INFORMATION BULLETIN

No.: V 410-9-I/61

Re: Supplements to technical descriptions and working instructions for the V 410

and the V 410A airscrews.

Fig. 1a - Electrical connexion of the airscrew unit

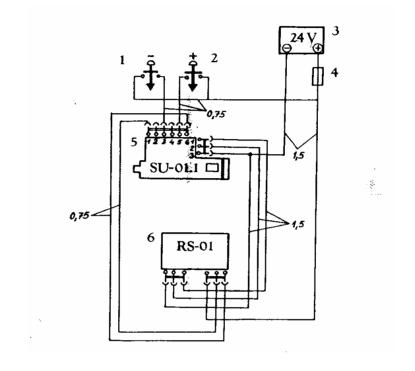
Airscrew unit with position control for single-engined airplanes VJ 1b.410

Two 5 K push-buttons switches are used for position control. They are built into the handle of the airplane gear shift lever and marked "+" and "-" with white colour.

By these push-buttons, the incidence of the airscrew blades in accordance with the corresponding flight or engine regime is set during flight. On depressing the push-button marked "+" the speed of the engine is increased (the incidence of the airscrew blades decreases), on depressing the push-button marked "+" the speed of the engine is reduced (the incidence of the airscrew blades increases). The two extreme positions of the setting of the airscrew blades are secured by terminal switches.

This airscrew unit is a temporary replacement for the VJ 1.410 airscrew unit.

Supplement No. 2 to the technical description and working instructions of the V 410 airscrew (1st issue)

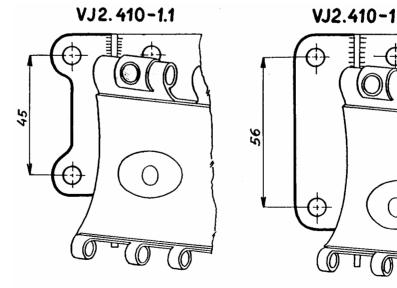
The manufacturing plant of M 332 engines has carried out a constructional modification on the engine case, by which the height of the lug for fastening the bracket of the airscrew electrical adjusting mechanism is altered. The bracket has to be adapted in compliance with this modification so as to ensure the accurate function for controlling the airscrew.

For this reason, it is necessary for the users of V 410 airscrew to state on ordering the spare bracket only or, as the case may be, the complete spare airscrew, for what engine (according to manufacturing number) the bracket will be used. Also, on mounting the airscrew on the engine, it is recommended to perform an inspection.

M 332 engines with higher lugs have been produced from manufacturing number 48245 onwards and airscrews with brackets according to the drawing number VJ 2.410-1.1 are supplied (this number of drawing is stated in the airscrew record book and it is punched, too, on the bracket). The meaning of this is that on no account may the VJ 2.410-1.1 bracket be applied for the M 332 engines with manufacturing number up to 48244 and vice versa.

The bracket for engine M 332 from manufacturing number 48245 onwards

The bracket for M 332 engine up to manufacturing number 48244
